Product Change

PCN of Huawei AR G3 -20130001 AR0MSLB1XA01 Interface Module

1. The following figure shows the appearance change.

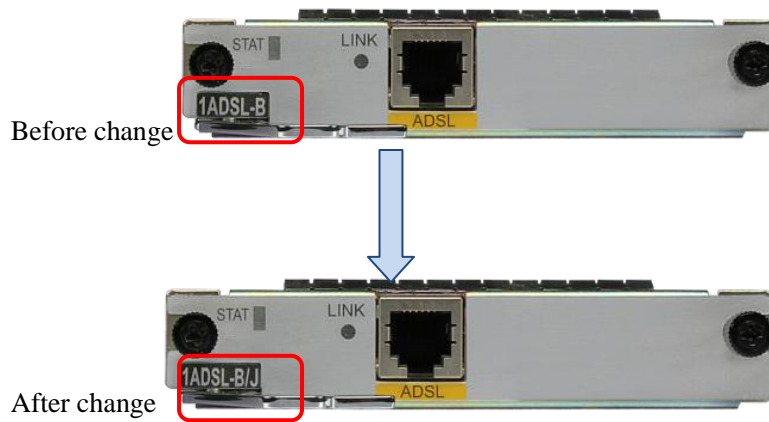
The AR0MSLB1XA01 interface module (1-Port ADSL2+ ANNEX B WAN interface module) originally supports only the ADSL2+ ANNEX B mode. Now it supports both the ADSL2+ ANNEX B and the ADSL2+ ANNEX J modes. The appearance of the module also changed and the module name changed from 1ADSL-B to 1ADSL-B/J (see attachment). These changes do not affect users that have bought the AR0MSLB1XA01 interface module with the ADSL2+ ANNEX B mode. The sales BOM remains unchanged (02310GBA).
